Westinghouse Electric Corporation

NS-TMA-2303

SUBJECT: Responses to "Request for Additional Information on Addendum 1 to WCAP-8720", NRC letter from J. R. Miller to T. M. Anderson, July 23, 1980

FIGURE 3. PEAK LOCAL POWER VERSUS PEAK LOCAL BURNUP FOR RODS WITH FISSION GAS RELEASE MEASUREMENTS

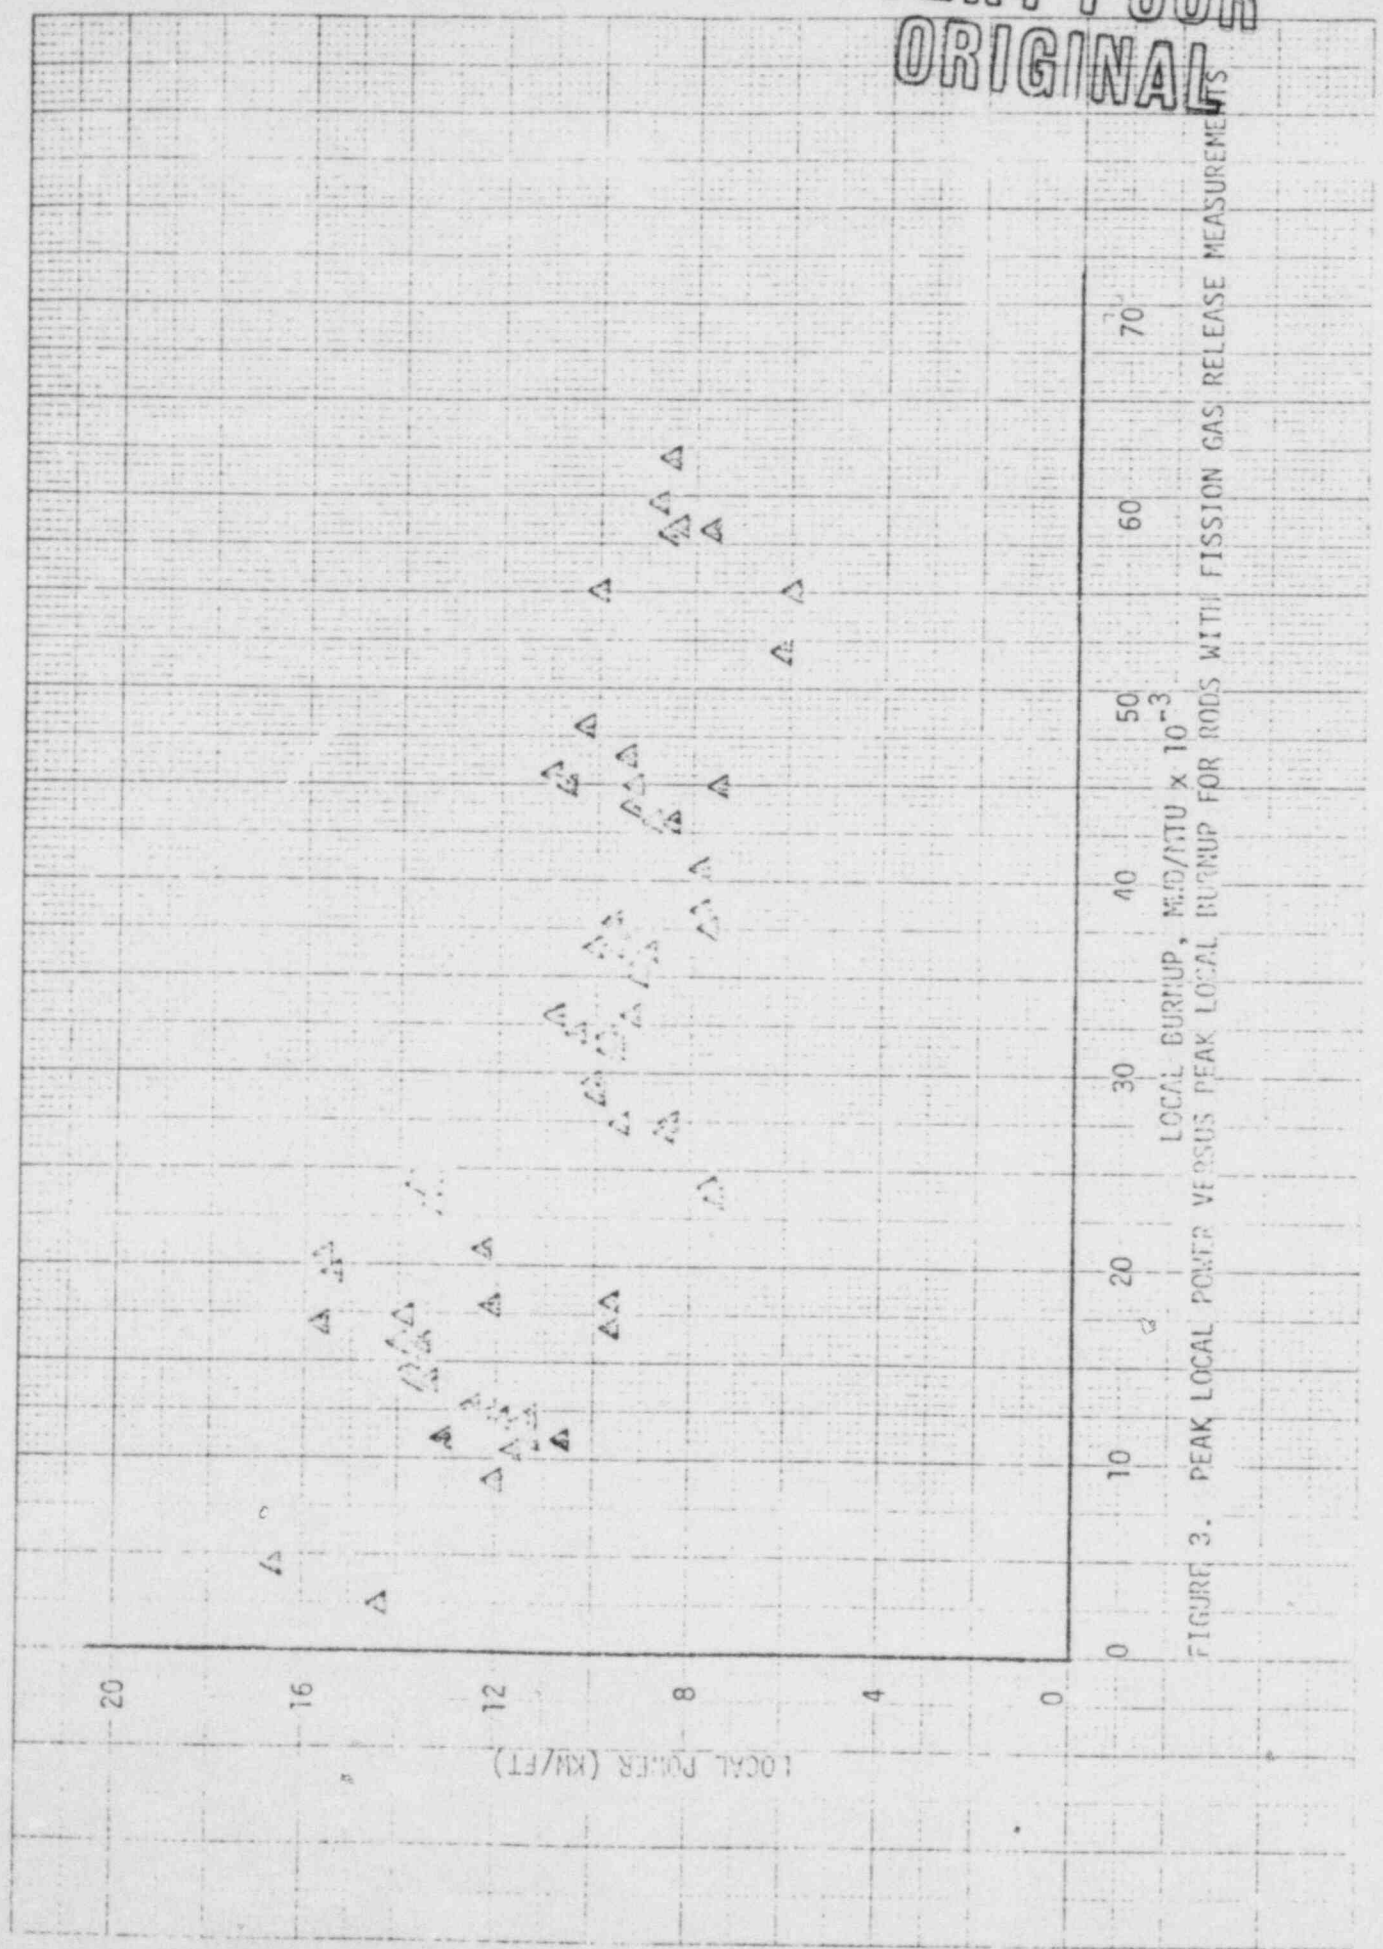
4. Explain why you believe the Westinghouse fission gas release model is applicable to all conditions during normal operation. Are there normal operating conditions outside of the data base for the gas release model? Specifically, consider the case of extended operation at low power to high burnup followed by high power operation for a period of greater than 50 hours.

The power histories for the rods given in the Attachment to Appendix B of WCAP-8720⁽¹⁾ were reviewed. Peak local powers in each cycle and at end-of-life were recorded. All of the peak powers recorded existed for time periods of at least one hundred hours. Peak local powers in each cycle and at end-of-life for representative rods are plotted versus local burnup in Figure 3. The data bound the values of peak local powers as functions of burnup that occur during normal operation of Westinghouse commercial PWRs. Thus, there are no normal operating conditions outside the data base for the gas release model.
